## Meeting Minutes Transmittal/Approval

Unit Managers Meeting: Grout Treatment Facility  
Westinghouse Office, Lacey, Washington  
Meeting Held April 23, 1992

Engineering Change Notices (B-714-114, -117, -118, -119, -120, -121 & -122)

Ref. Dwg.  
H-2-77581

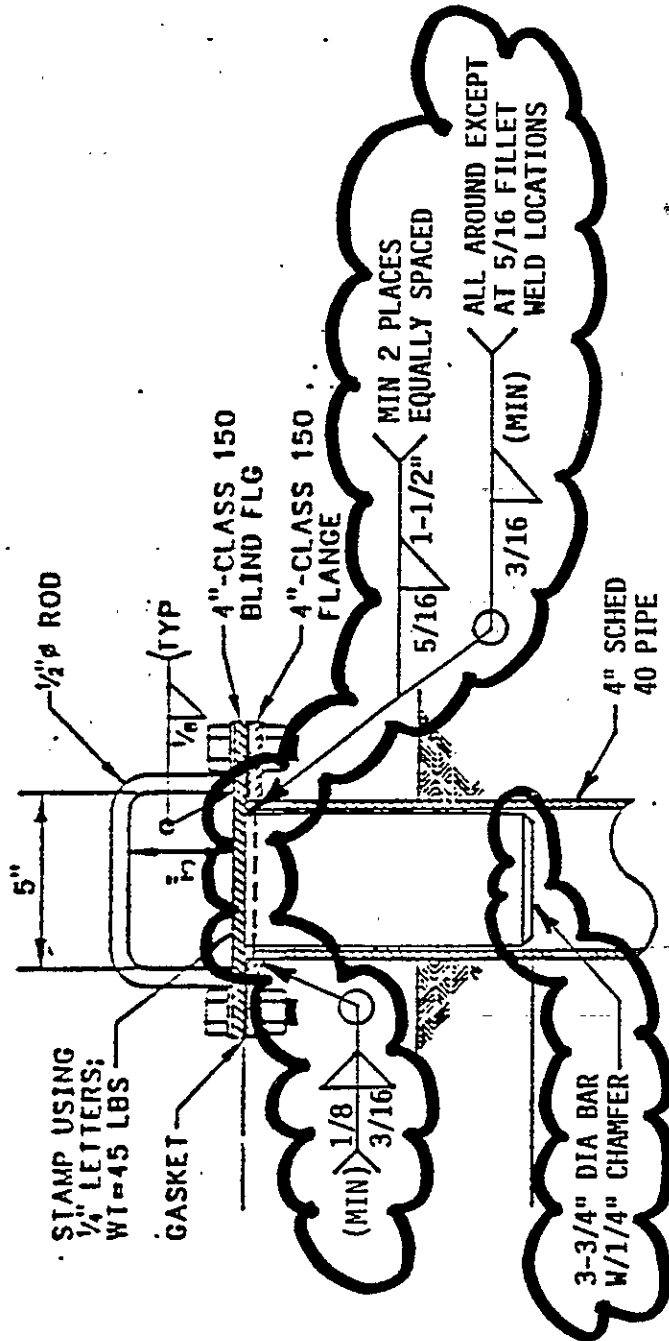
Detail 8 (Z C7): Modify as shown on page 4 of this ECN.

Ref. Dwg.  
H-2-77590

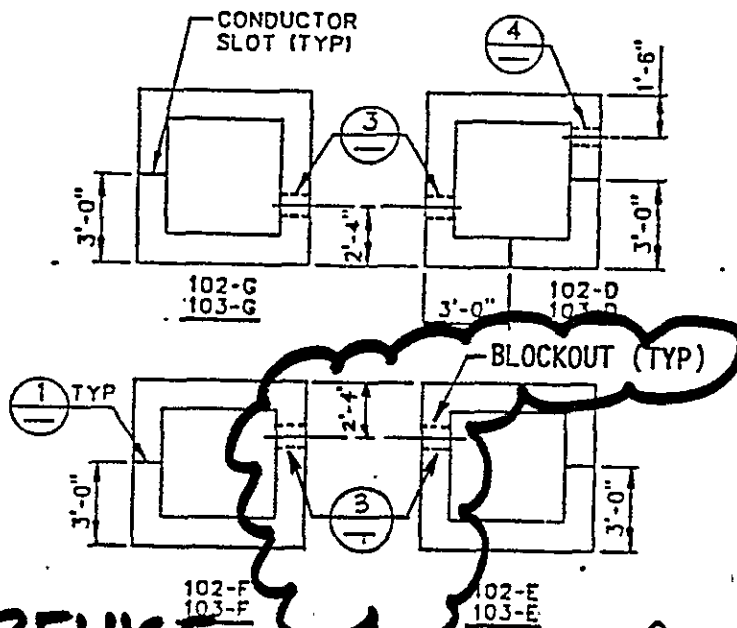
Arrangement Plan (Z C3): Relocate blockouts as shown on page 5 of this ECN.

Ref. Dwg.  
**H-2-77591**

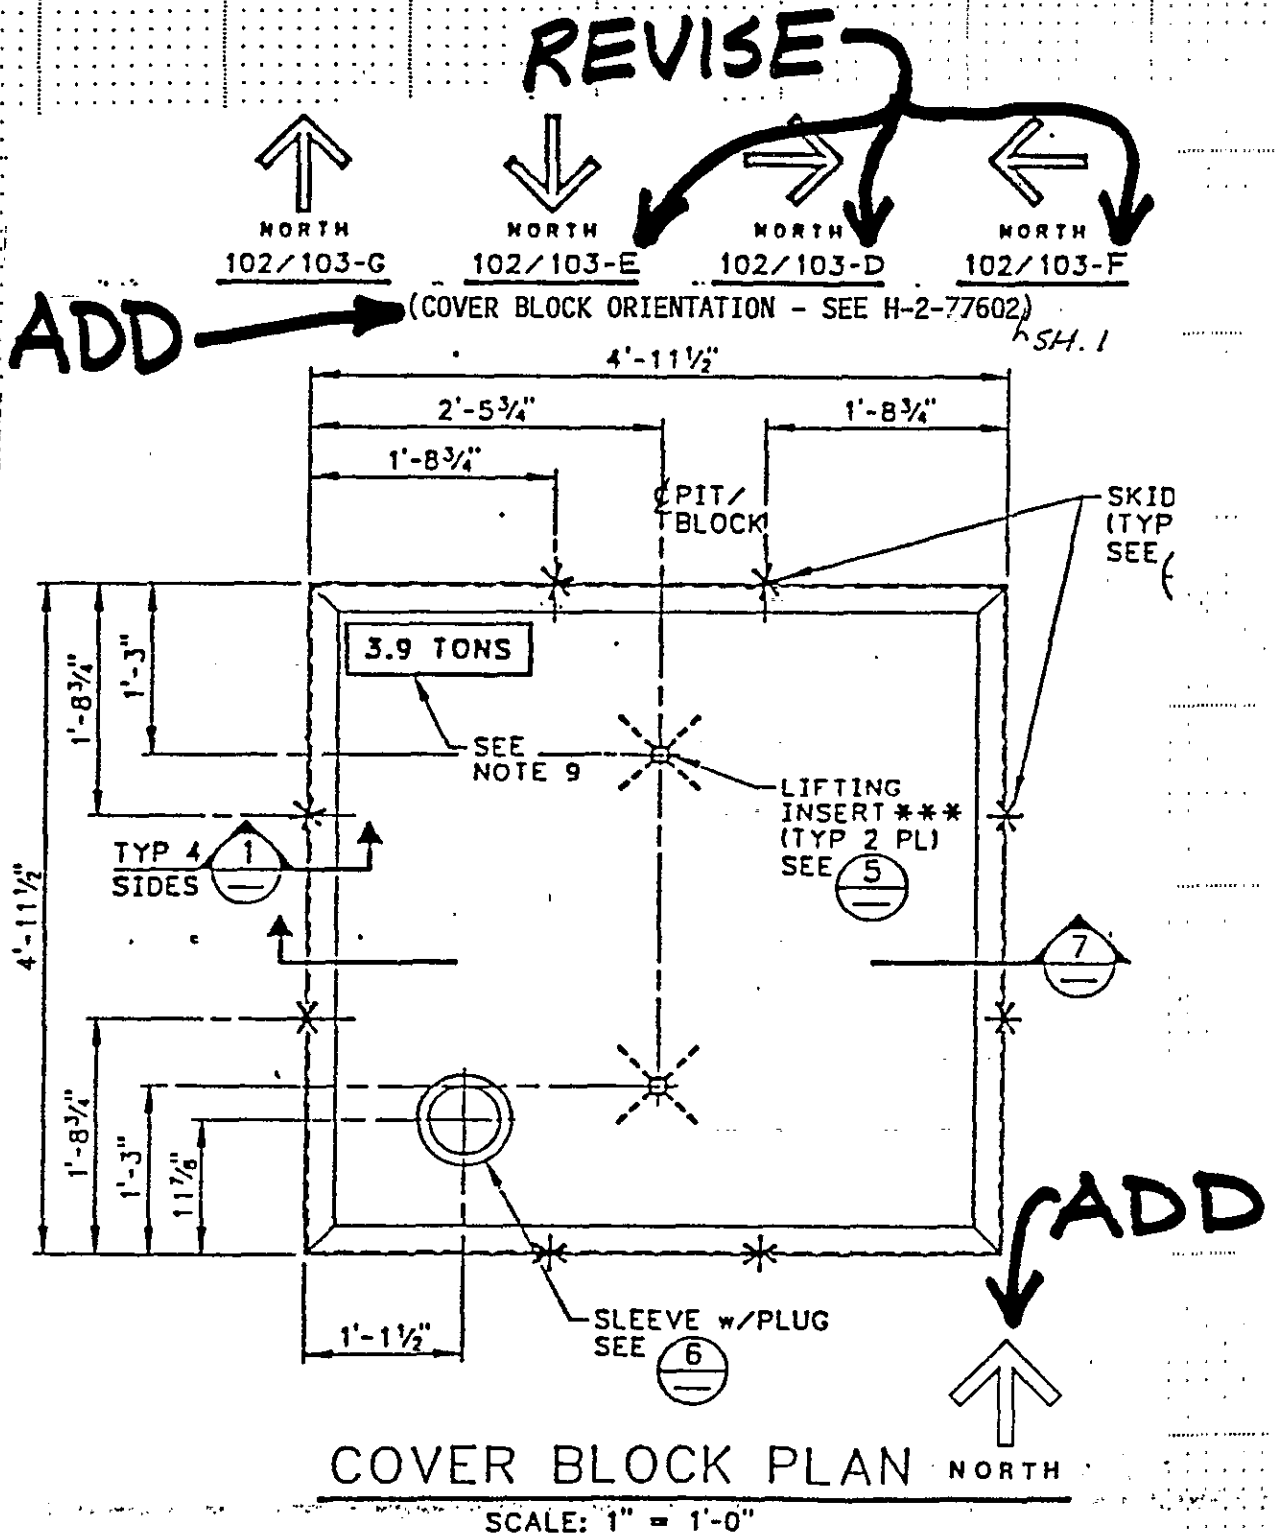
Cover Block Plan (Z F7): Reorient North arrows as shown on page 6 of this ECN.

Ref. Dwg.  
H-2-78457

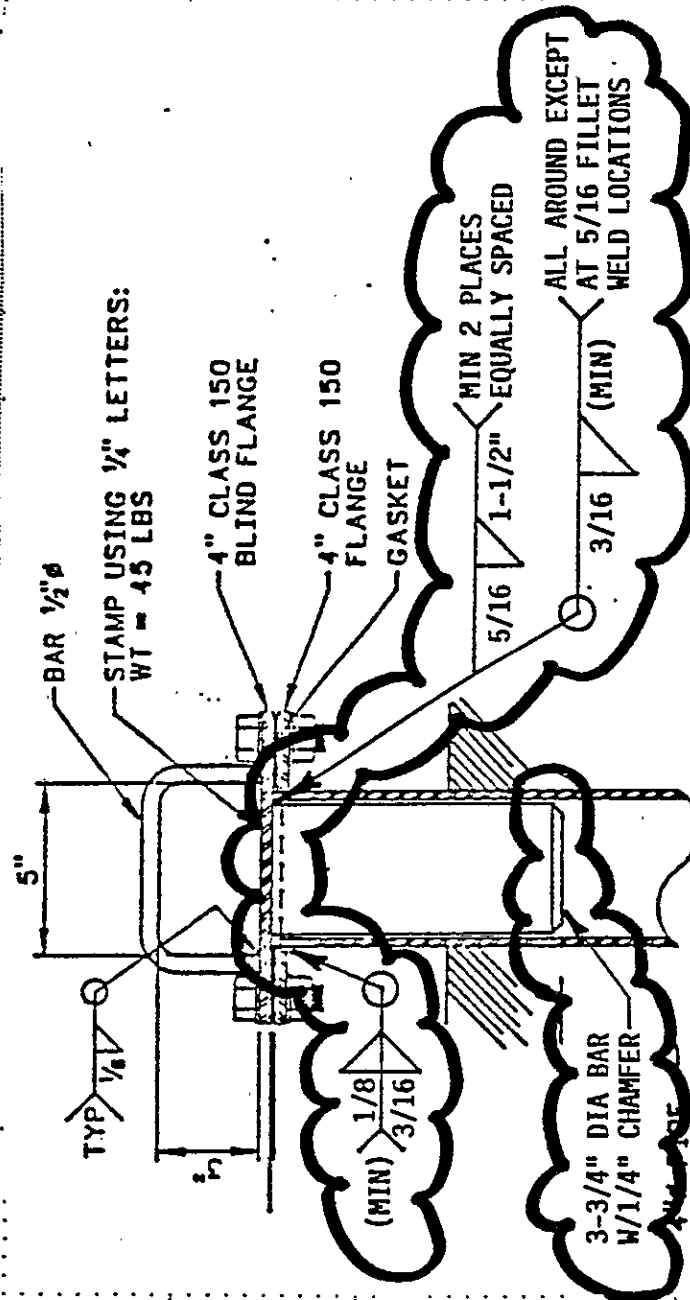
Detail 4 (Z D3): Modify as shown on page 7 of this ECN.

## ENGINEERING CHANGE NOTICE SKETCH

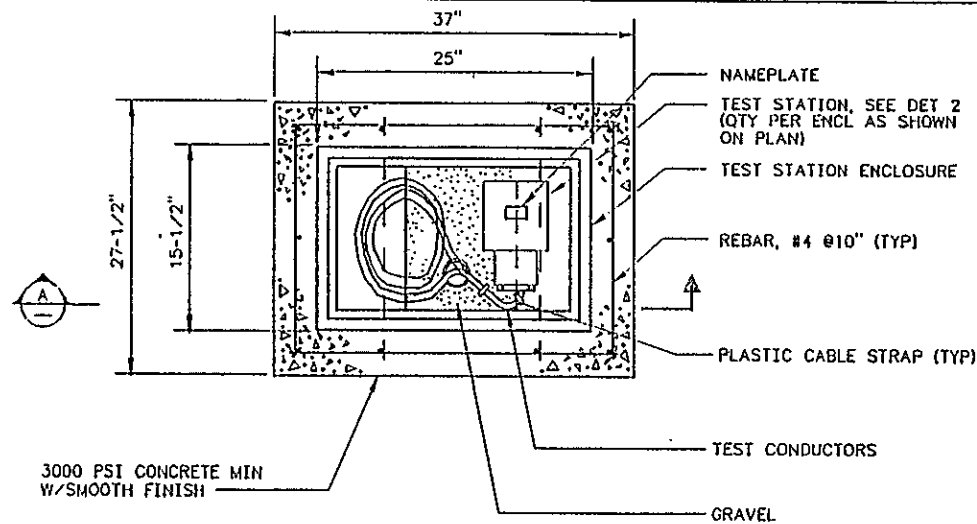
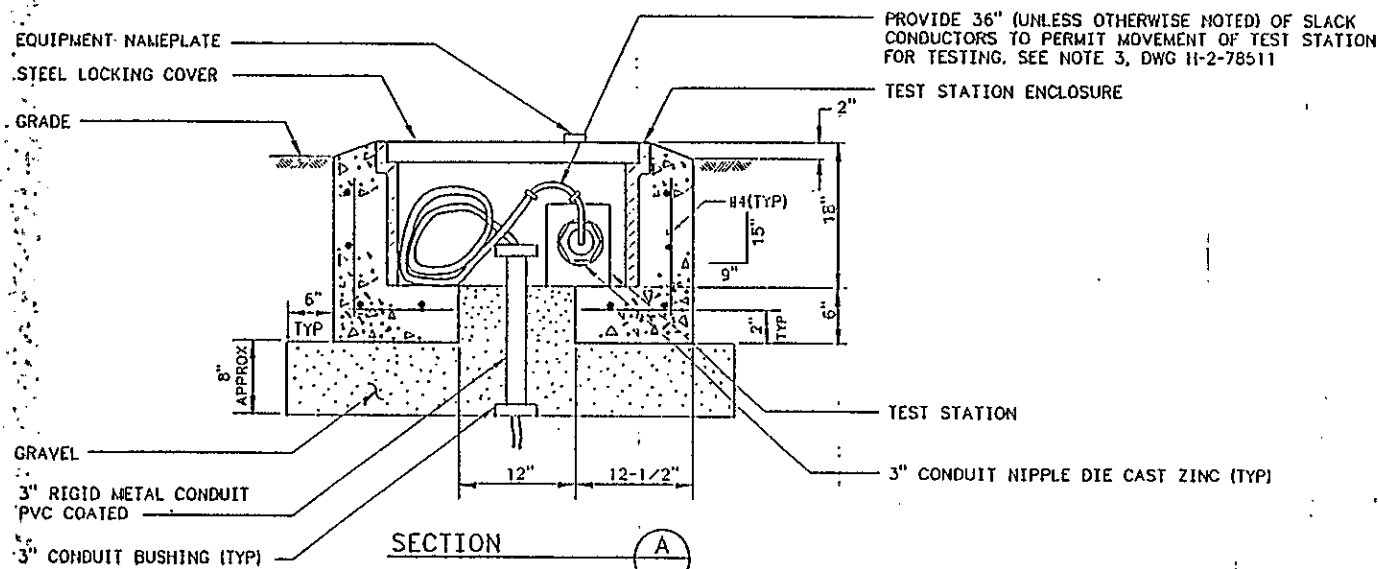
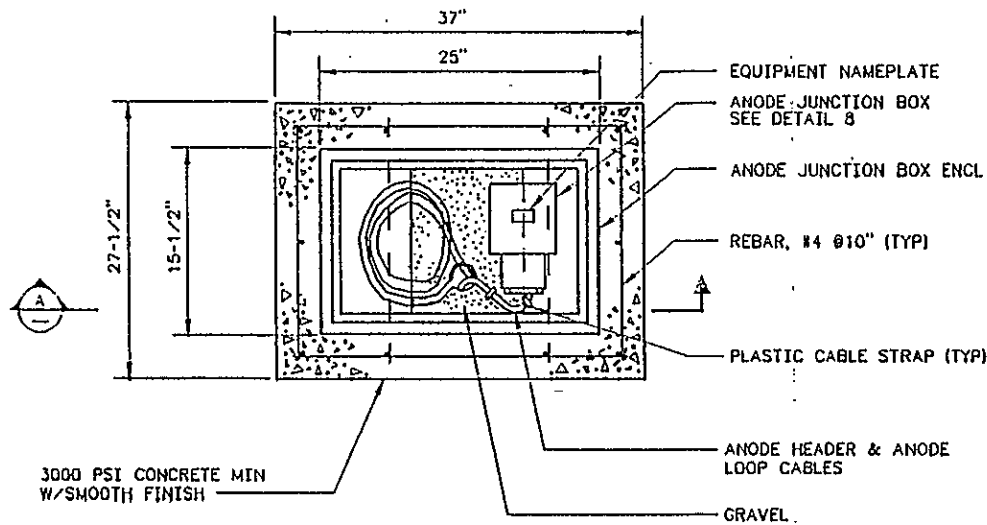
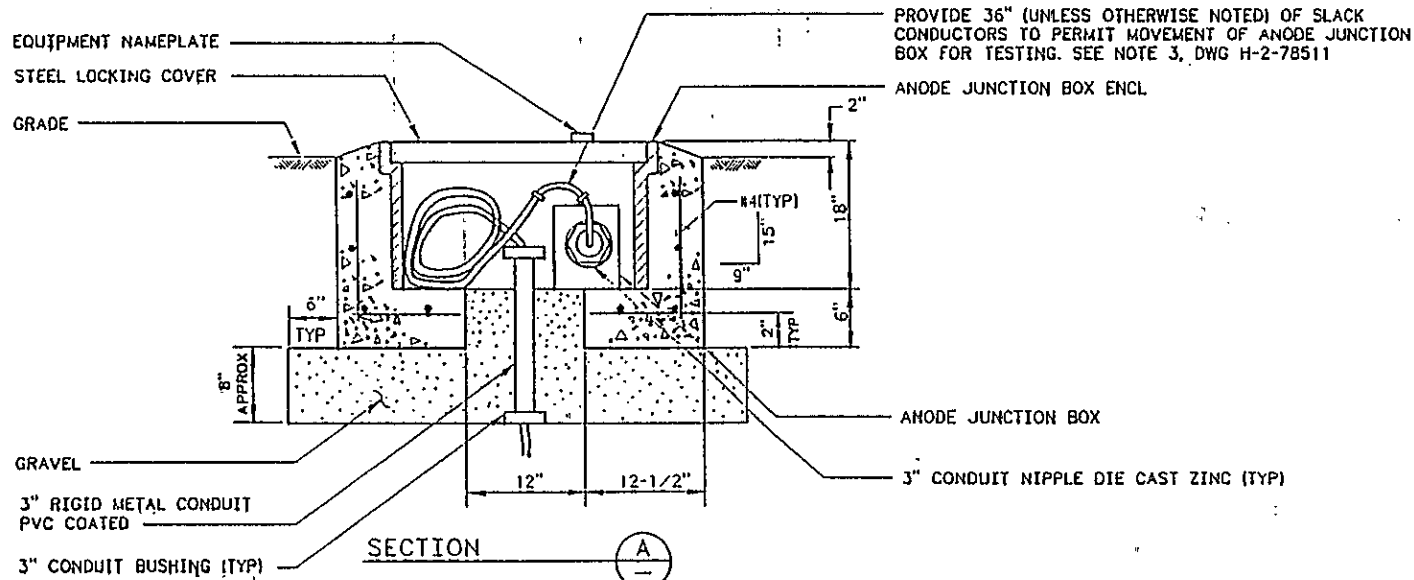
- 3) H-2-77645, Sh 1, Rev 1  
Anode Location Table (Z B8): Change West Coordinate for A(45-5) to "W45896"
- 4) H-2-78512, Sh 1, Rev 1  
Detail 3 (Z C4-F6): Replace - see page 4 of this ECN.

- 5) H-2-78513, Sh 1, Rev 1  
Detail 9 (Z C4-F6): Replace - see page 5 of this ECN.
- 6) SPEC B-714-C2, SECTION 09805  
A) Renumber para 2.1.1 to 2.1.2 and change to read:  
Filler: Carboline 195 Surfacer.

DETAIL B  
SCALE: 3"=1'-0"

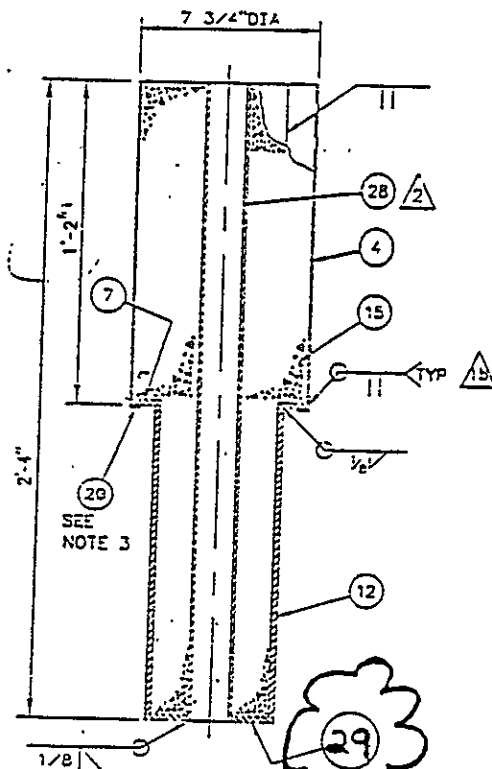
- A) Parts List: Modify - see page 4 of this ECN.  
B) Detail B (Z 5A): Revise callout for PN2 to PN29 as shown on page 5 of this ECN.  
C) Detail A (Z 5D): Add callout for PN30 at location of PN14 as shown on page 6 of this ECN.

- A) Parts List: Modify - see page 4 of this ECN.  
B) Detail B (Z 5A): Revise callout for PN2 to PN29 as shown on page 5 of this ECN.  
C) Detail A (Z 5D): Add callout for PN30 at location of PN14 as shown on page 6 of this ECN.

Ref. Dwg.  
H-2-77582

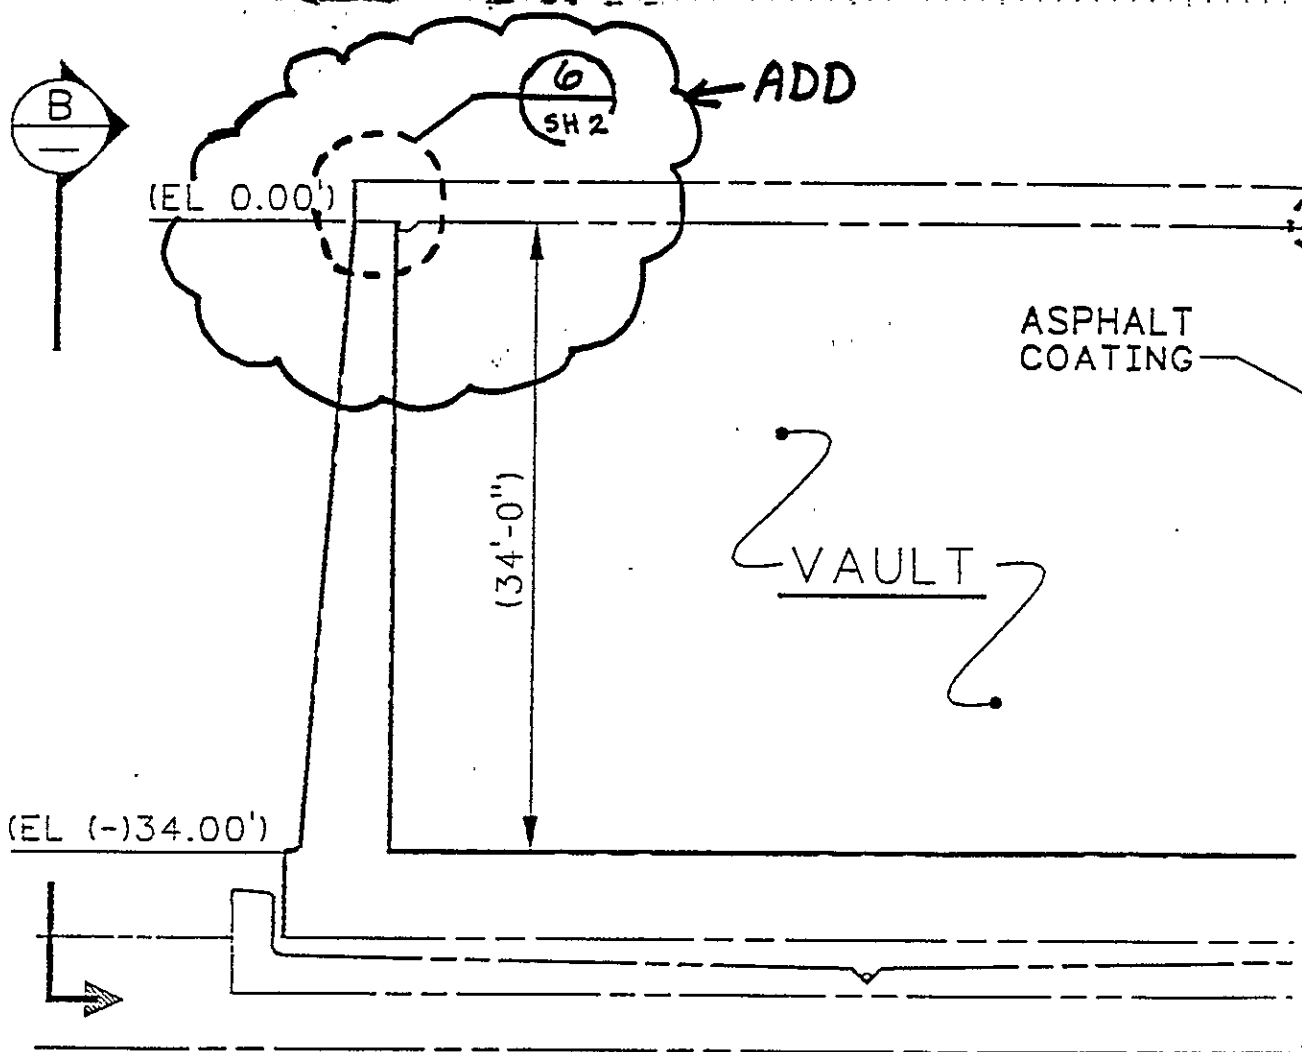
Section A (Z F4): Add detail bubble as shown on page 4 of this ECN.

**OPTIONAL HDPE CURTAIN ARRANGEMENT**

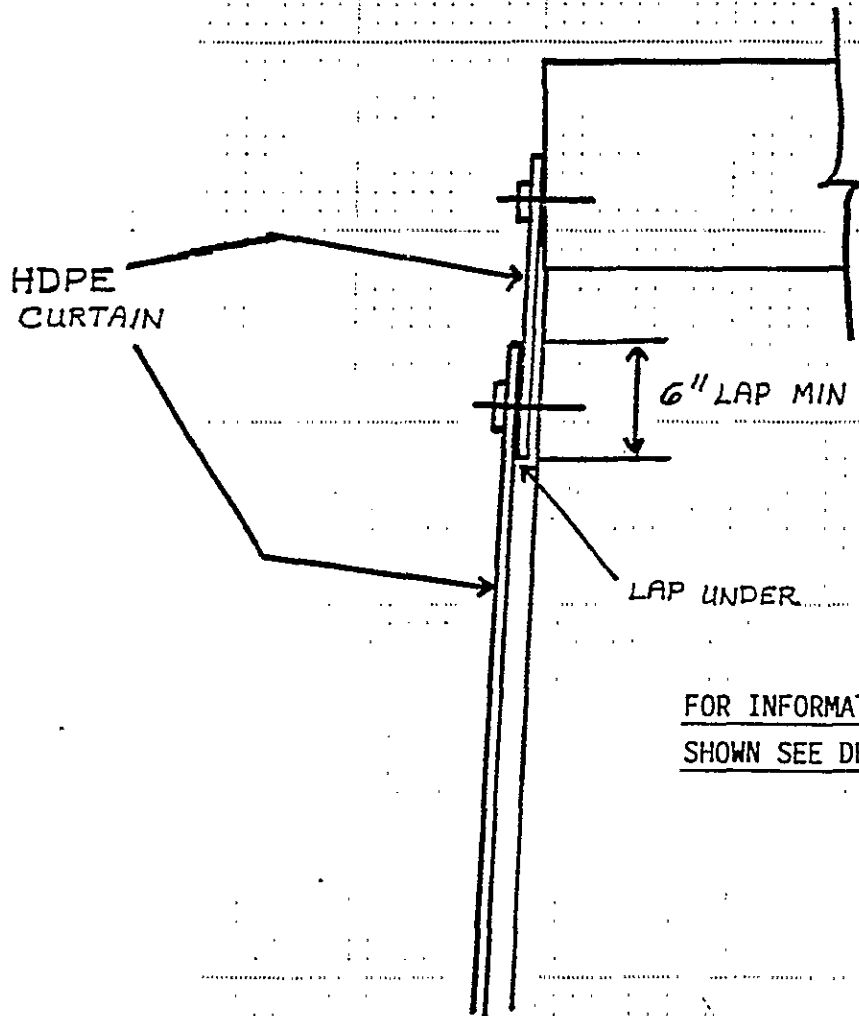
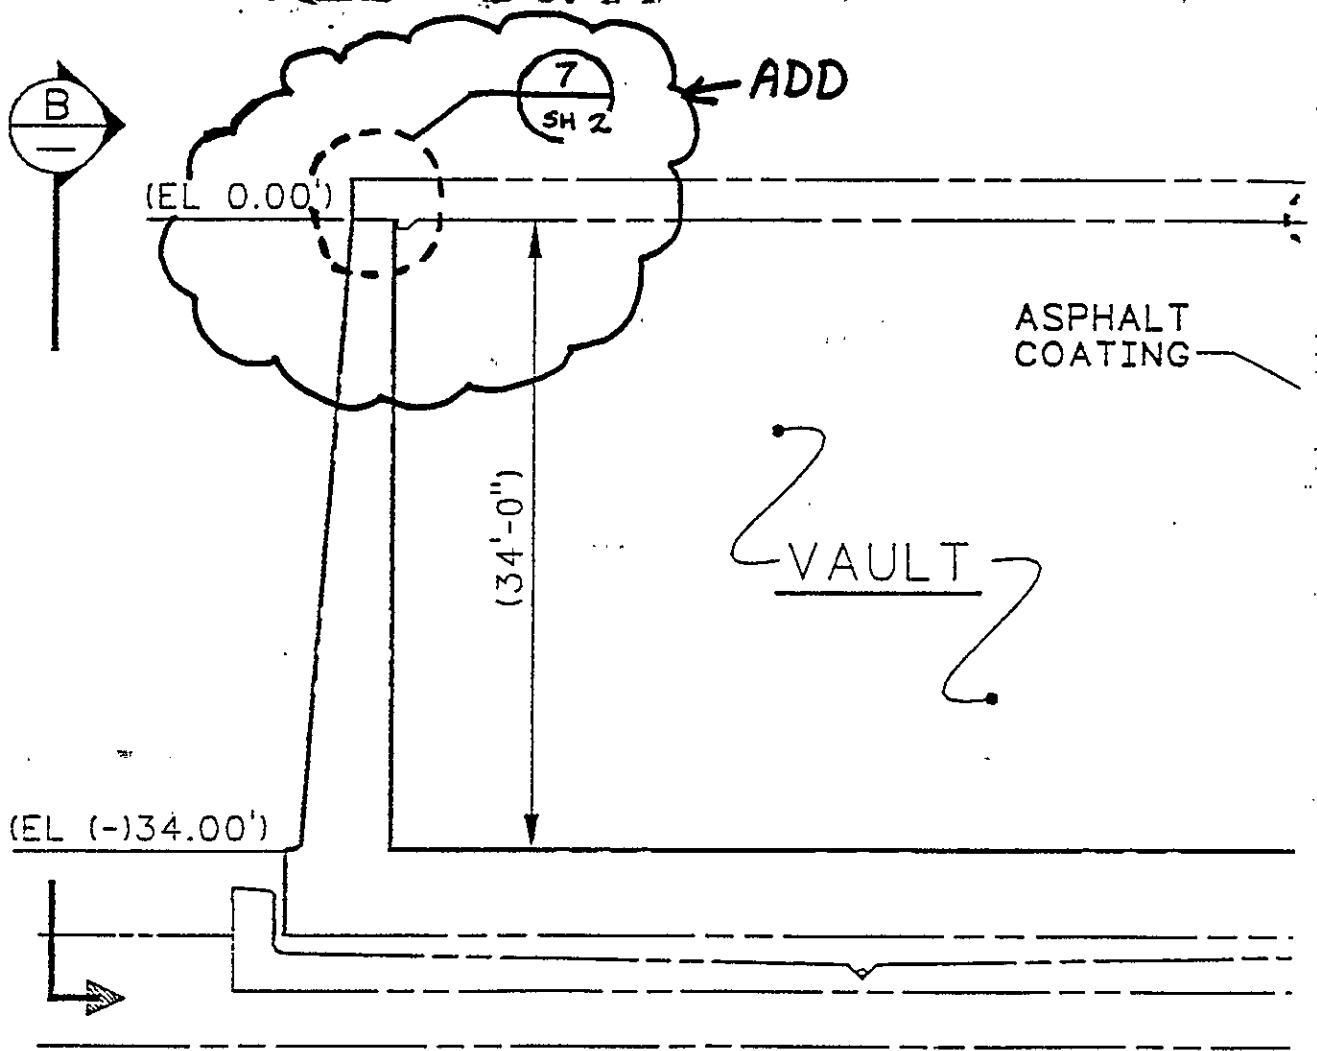
B) Add new Detail 6 as shown on page 5 of this ECN.

B) Add new Detail 7 as shown on page 7 of this ECN.
